SITE PLAN FOR CLEAN EXPRESS CAR WASH

10 E AUBURN ROAD ROCHESTER HILLS, MI 48309

MICHIGAN
Utility Notification
CENTER
811
811 or
1-800-482-7171
Know What's Below. Call Before You Dig.

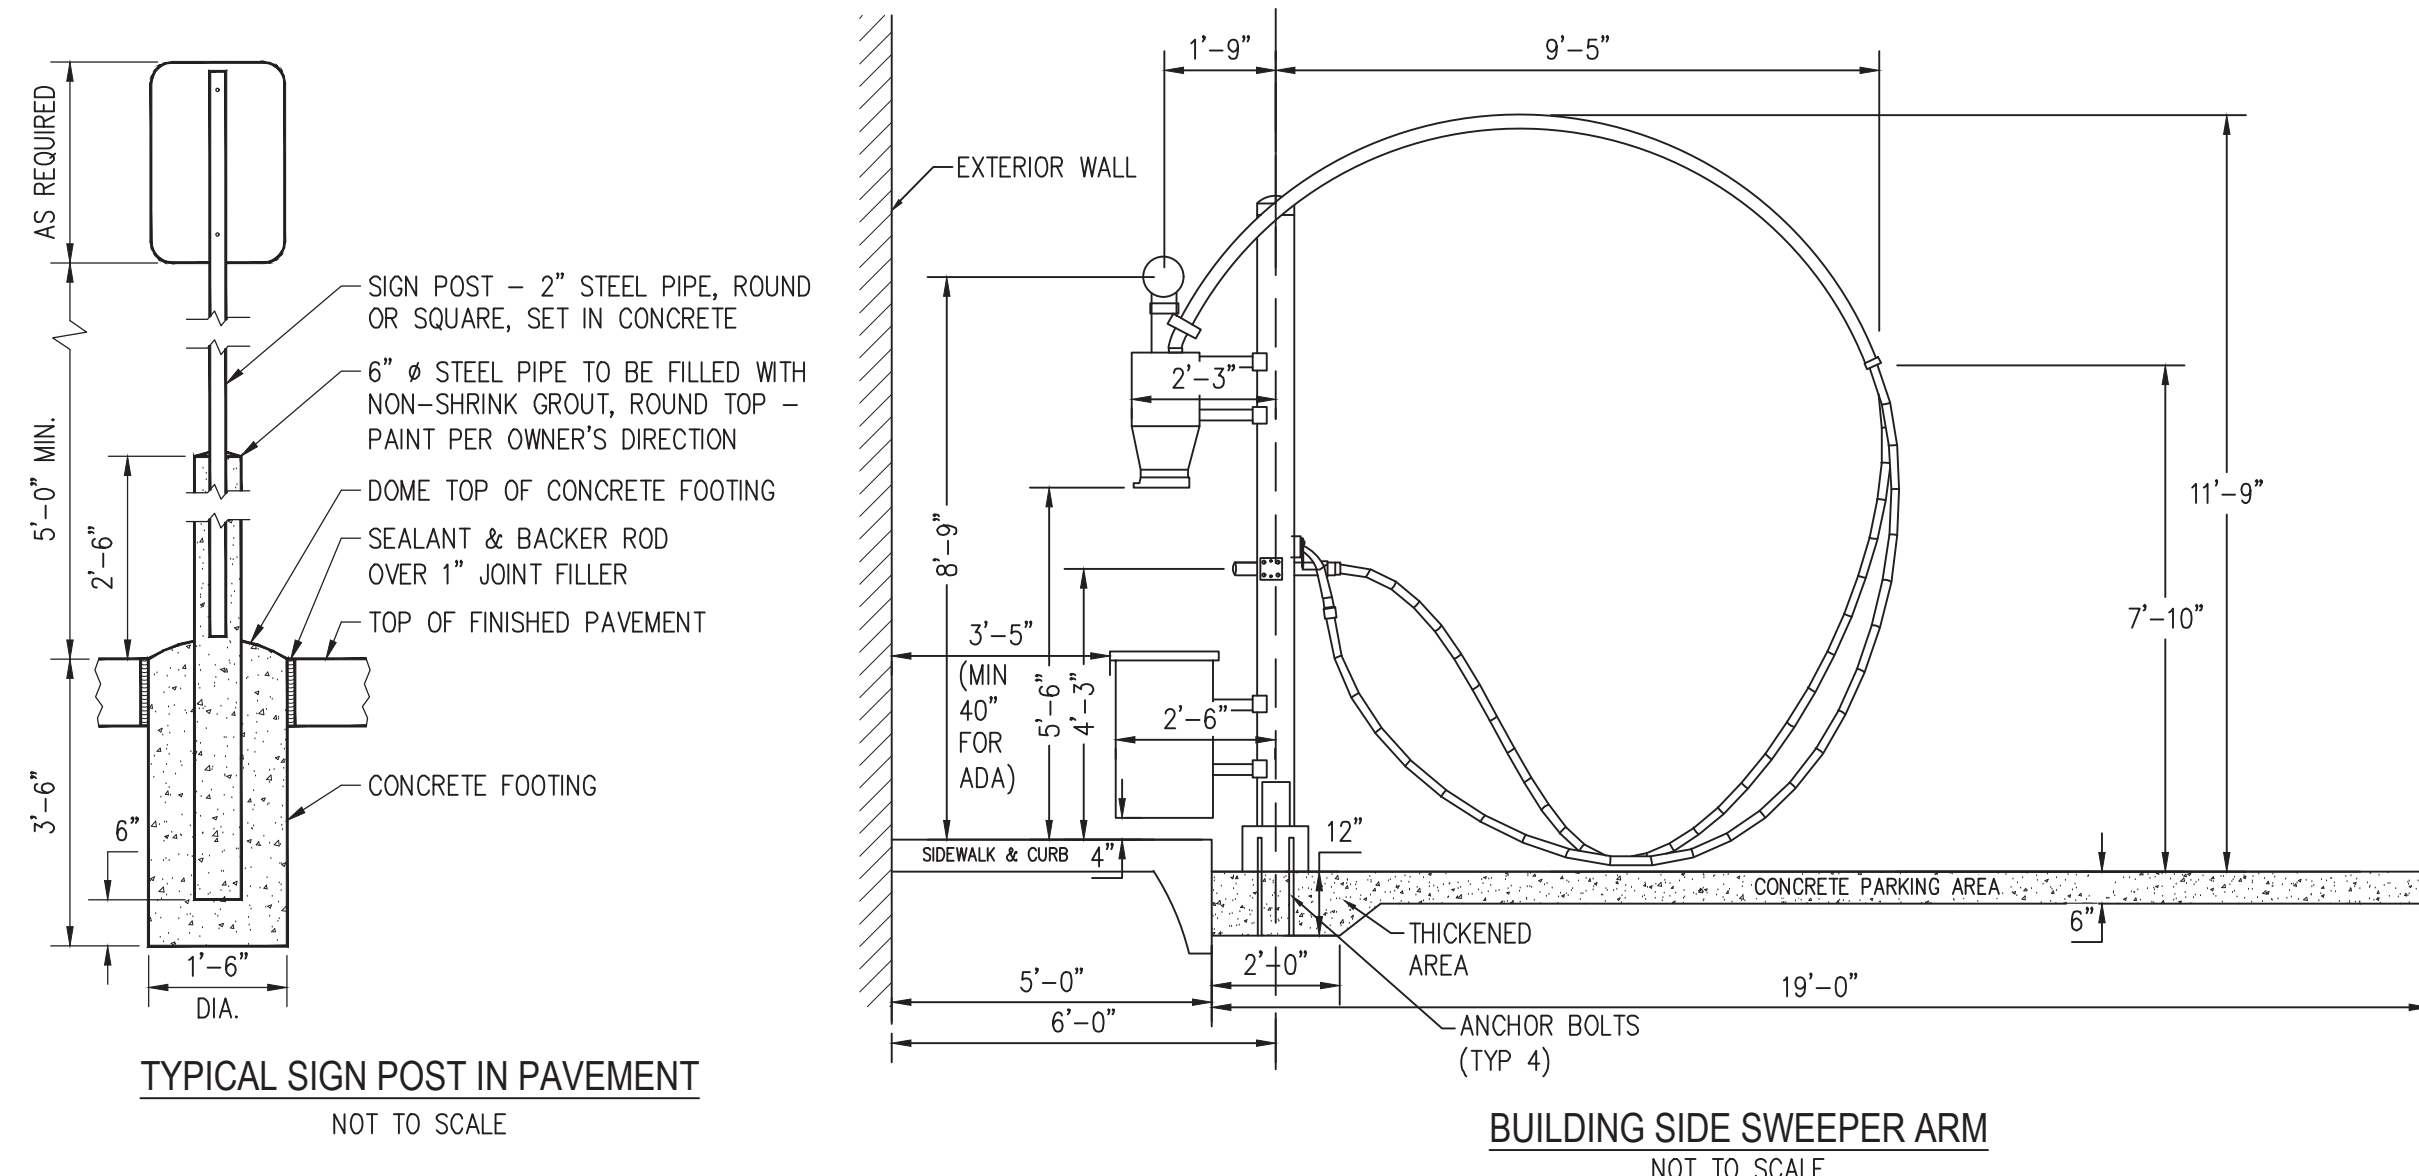
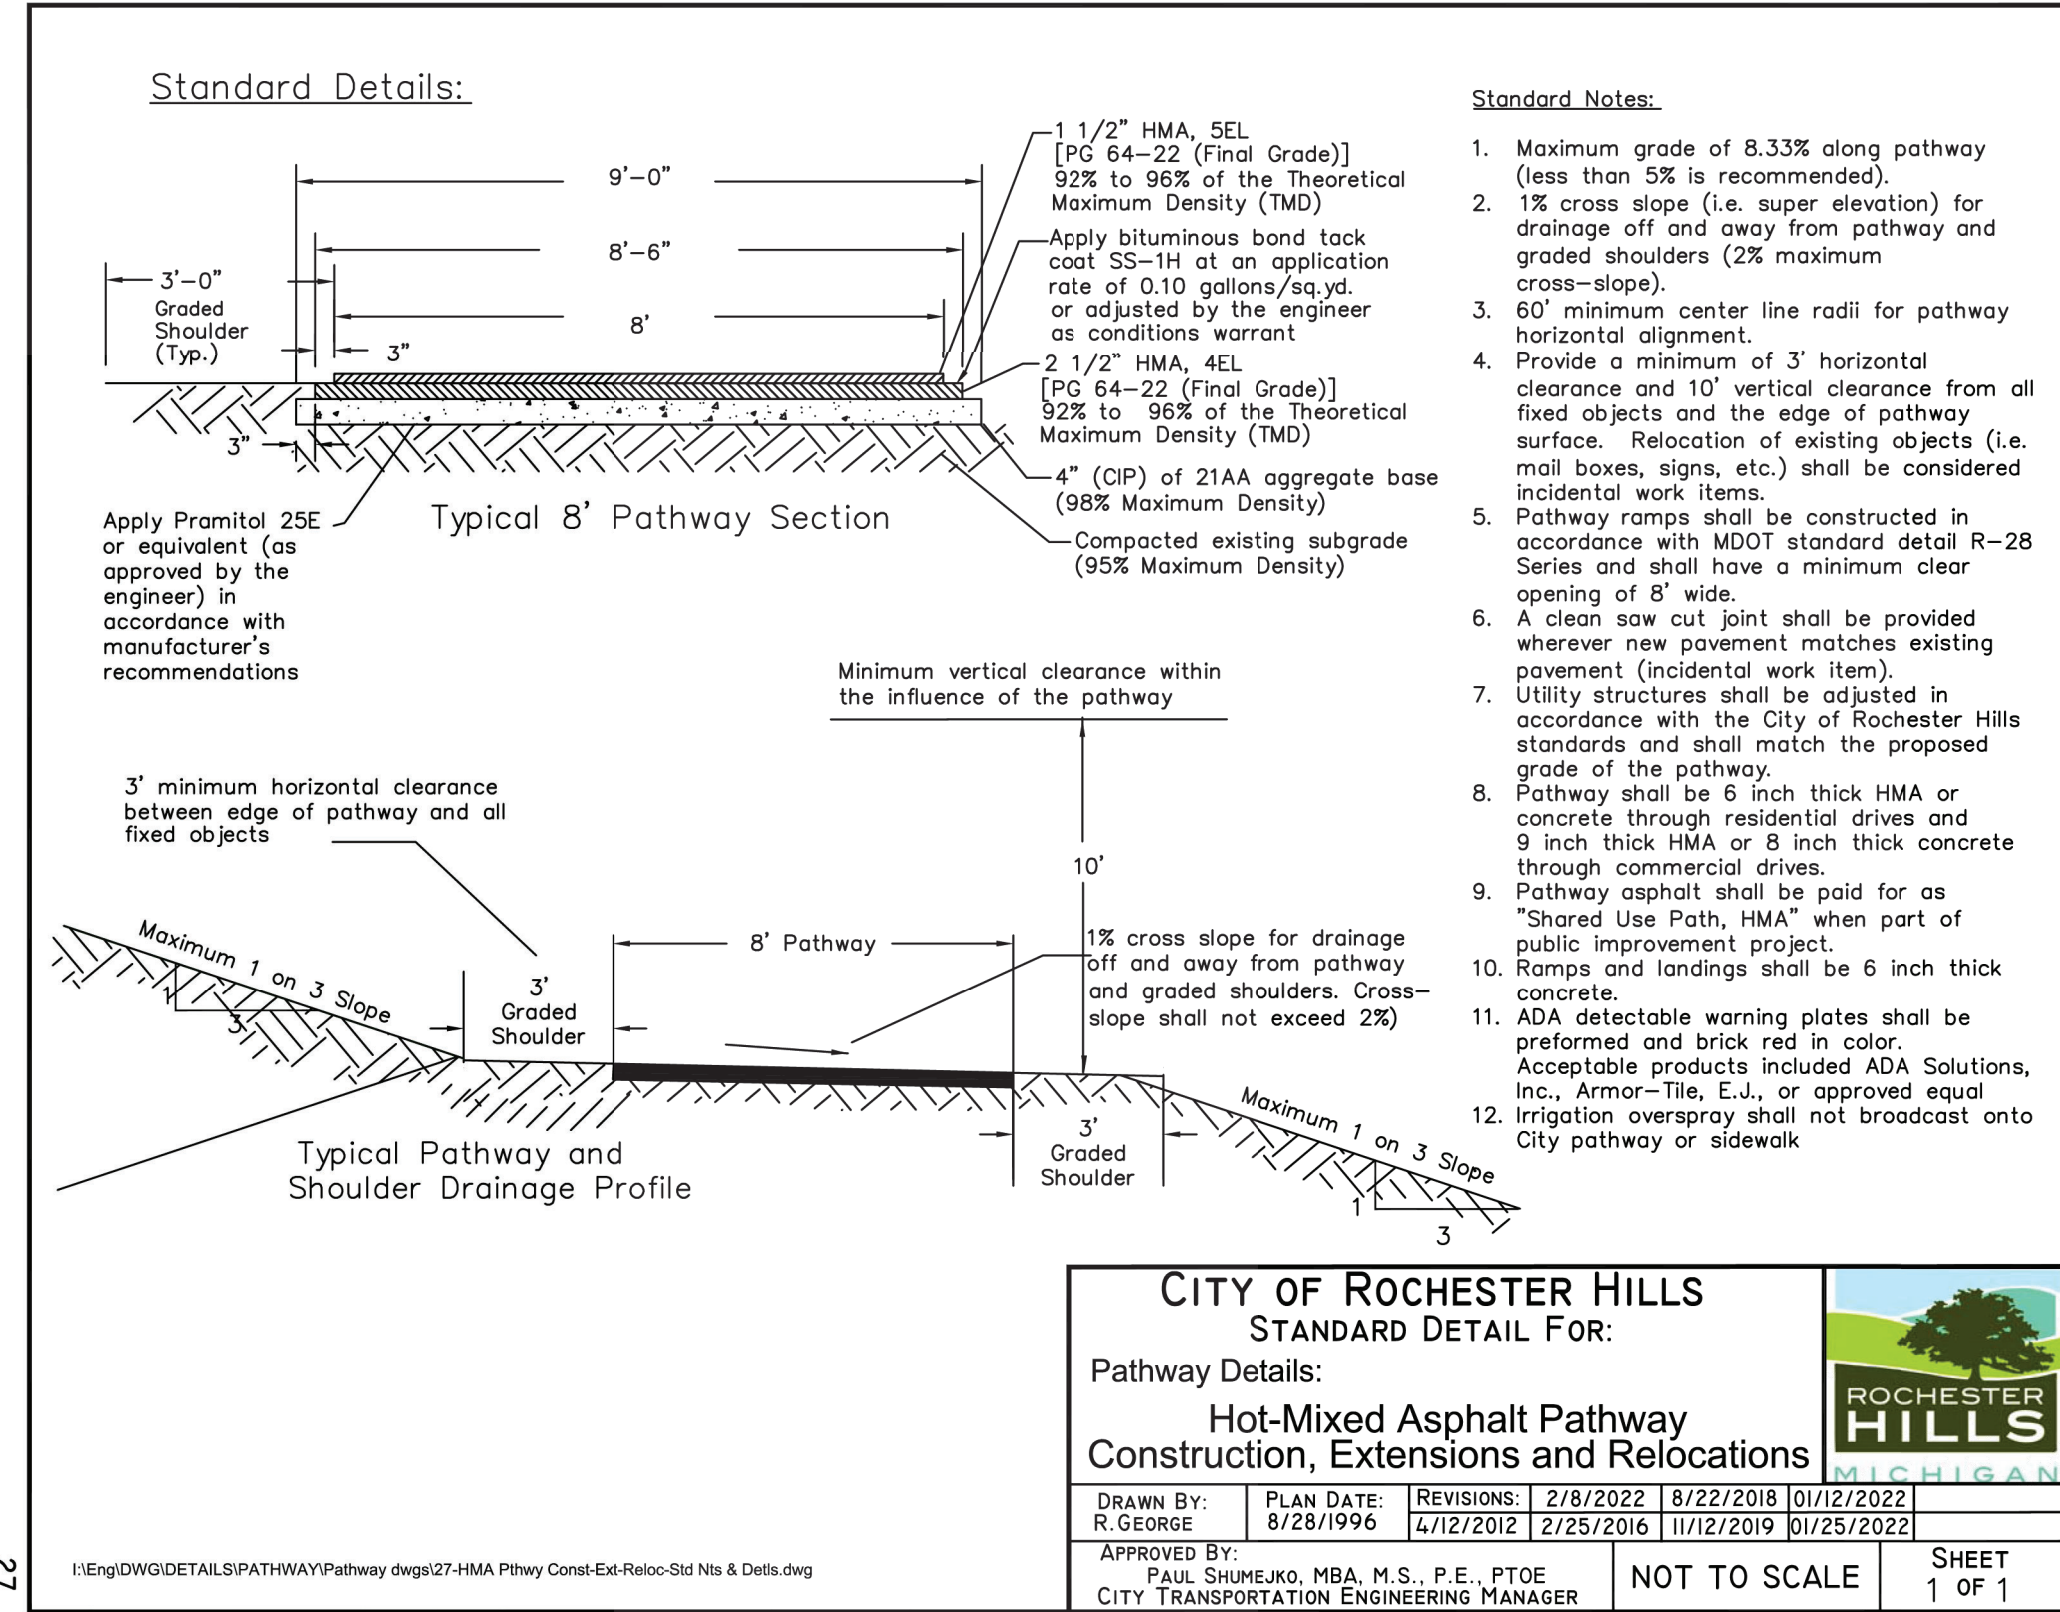
The applicant needs to submit a Land Improvement Permit (LIP) application with engineer's estimate, fee and construction plans to proceed with the construction plan review process.
